15. COA-050423-2019

2816 East Franklin Street

Commission of Architectural Review

STAFF REPORT

Figure 1. Sanborn Map, 1905

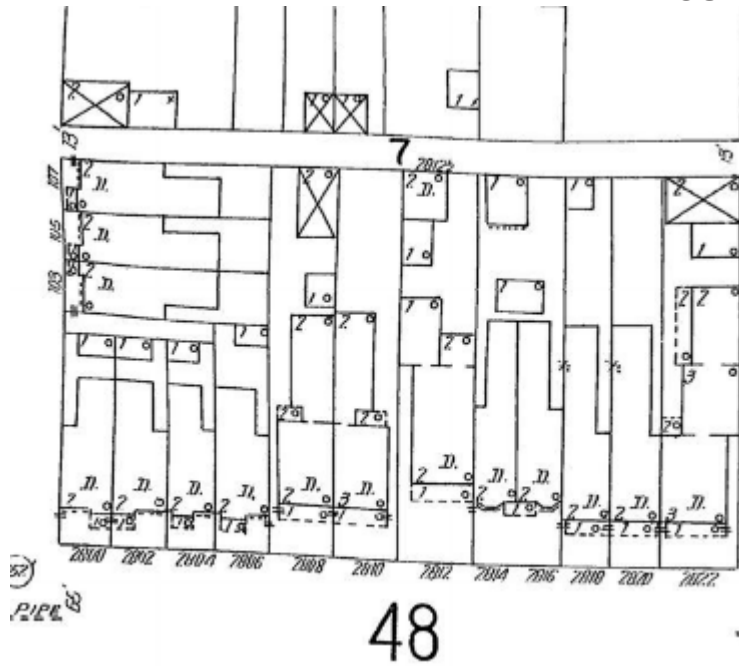
It is difficult to determine if the existing garage is the structure shown in the 1905 Sanborn map, however historically there has been a one-story building at the rear of the property. The current garage was formerly attached to a garage at 2814 East Franklin Street which was demolished in 1975. The west wall of the existing garage was replaced with CMU.

The mass of the proposed secondary building is smaller than the primary resource, and located at the rear. Sanborn maps indicate historically a one-story outbuilding has been present on the site since at least 1905. The Sanborn maps also indicate that historically two-story buildings have been located on the subject alley, though none are still standing.
